City of Phoenix
PLANNING AND DEVELOPMENT DEPARTMENT

RE: ALTA Marlette (Z-27-17) Minor Amendment and Requests for Clarification

RE: ALTA Marlette re Requests for Clarification for Z-27-17
Request for Minor PUD Amendment
Approximately 165 feet East of the Northeast
Corner of 7th Street & Marlette Avenue

Overall Development – Conceptual Site Plan for Multi-Family Community

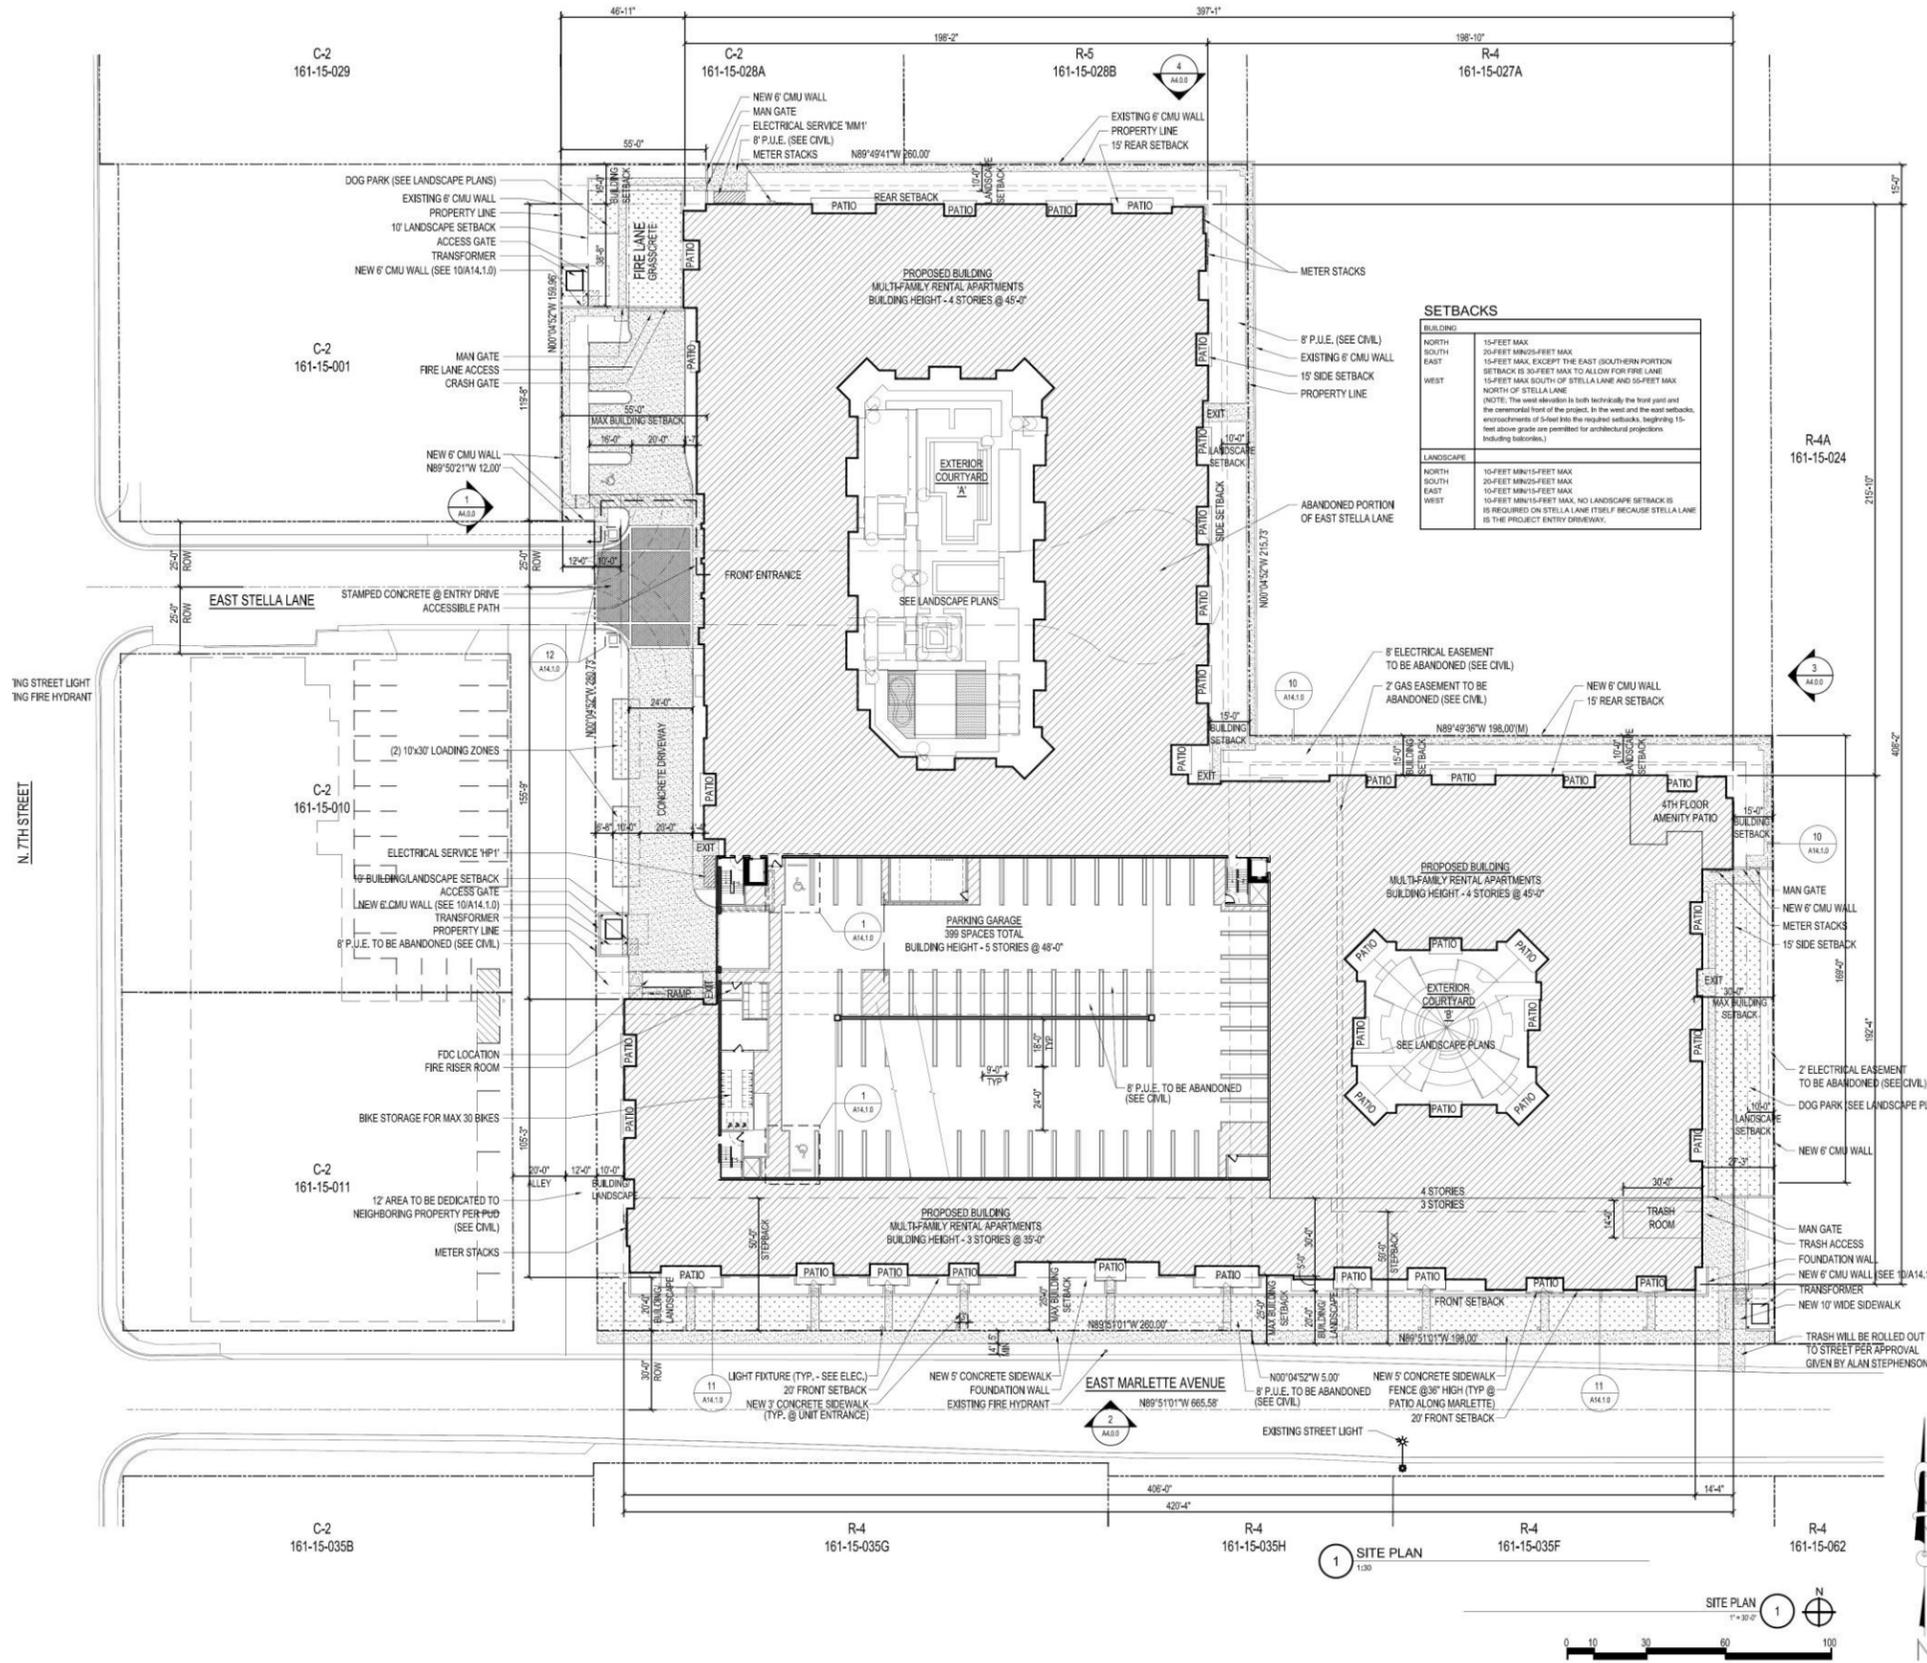
- 2) *Regarding building setbacks; That the required 15-foot maximum building setbacks on the west side of the property south of Stella Lane has been satisfied as shown on the illustrative site plan in the PUD that was consistent throughout the hearing process and by the DSD preliminary site plan. The purpose of the maximum setback was to preclude the ability to revise the development to place parking fields around the perimeter of the building.*

- Regarding Building Setbacks;
That the required 15-foot maximum building setback on the west side of the property south of Stella Lane has been satisfied as shown on the illustrative site plan in the PUD that was consistent throughout the hearing process and by the DSD preliminary site plan. The purpose of the maximum setback was to preclude the ability to revise the development to place parking fields around the perimeter of the building. This design feature has been accomplished.

The illustrative site plan included in the finalized PUD narrative depicts a maximum 15-foot building setback south of Stella Lane and south of the parking garage structure. This configuration is consistent with the narrative's site development standards while allowing for access from the project's entry to the internalized parking garage.

Proposed Conceptual West Elevation

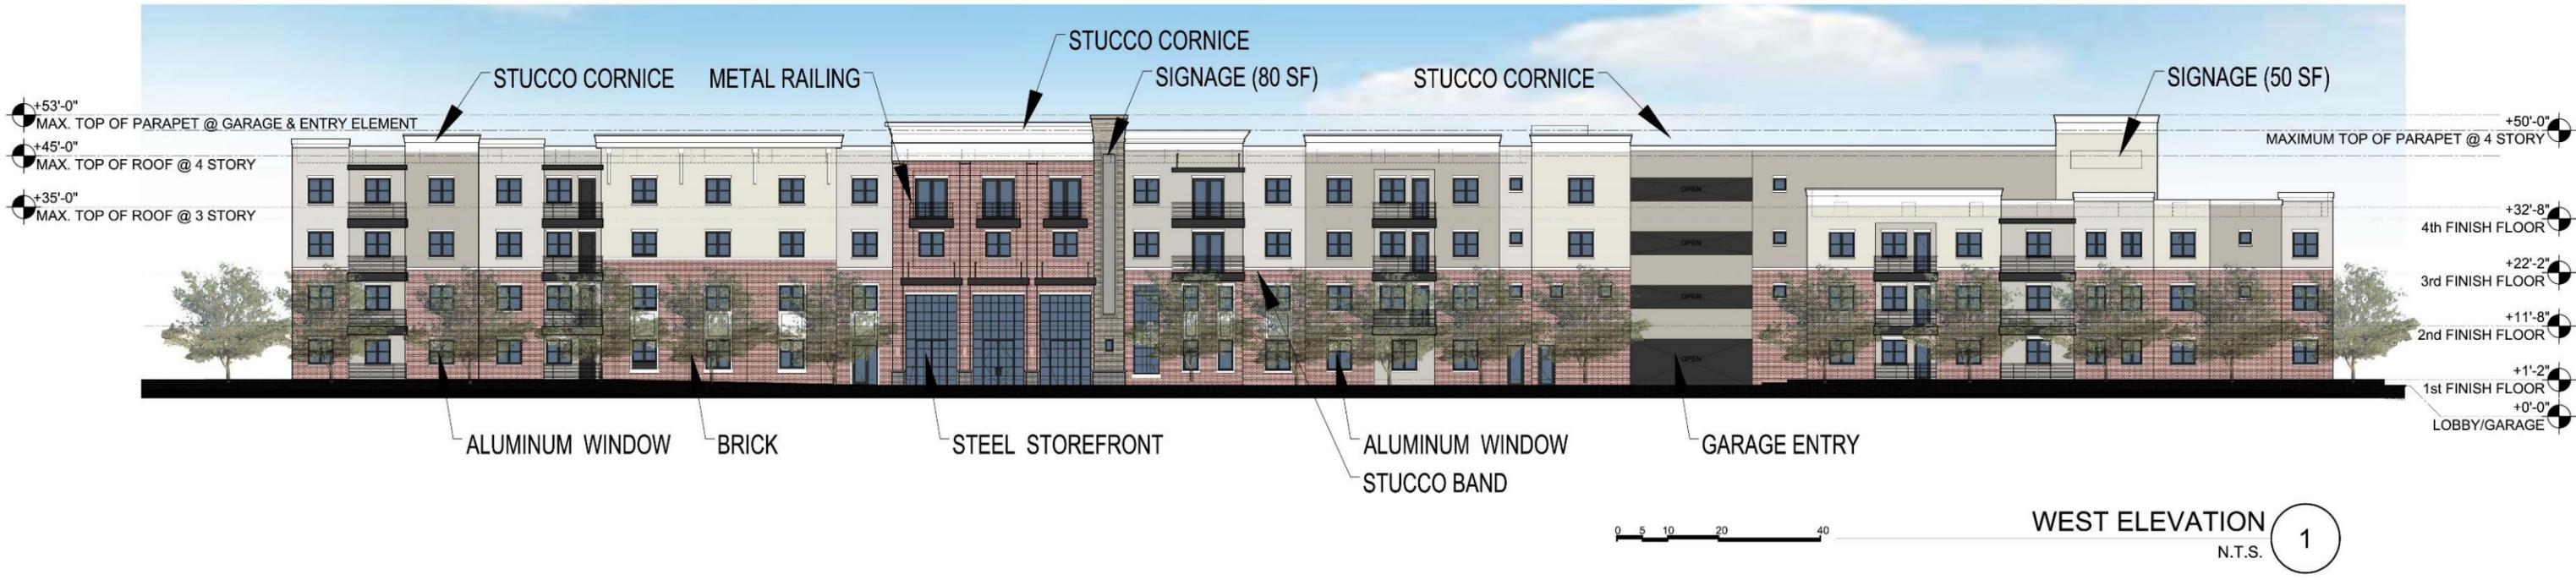
- 5) *The West Elevation that was modified to accomplish the required reduction of units down to a maximum of 229, is in general conformance with the illustrative exhibits in the PUD. Even though units were removed from the western elevation of the parking garage the west elevation of the garage faces the back side of a commercial center and this elevation was designed to be consistent with the architectural theme of the balance of this west side of the project.*

- The West Elevation that was modified to accomplish the required reduction of units down to a maximum of 229, is in general conformance with the illustrative exhibits in the PUD. Even though units were removed from the western elevation of the parking garage the west elevation of the garage faces the back side of a commercial center and this elevation was designed to be consistent with the architectural theme of the balance of this west side of the project.

As you note, units were removed from the southern section of the western elevation to account for the reduction in units ultimately approved by City Council. Due to this reduction in units, minor adjustments to the western elevation are warranted. The western elevation included in Exhibit J of your letter would be considered in general conformance to the stipulated elevations contained in the Development Narrative. While considered to be in general conformance, the revised elevations will need to demonstrate compliance with the narrative's design guidelines, including the provisions for four-sided architecture, percentage of brick façade, architectural embellishments and building articulation, through the final site plan approval process.
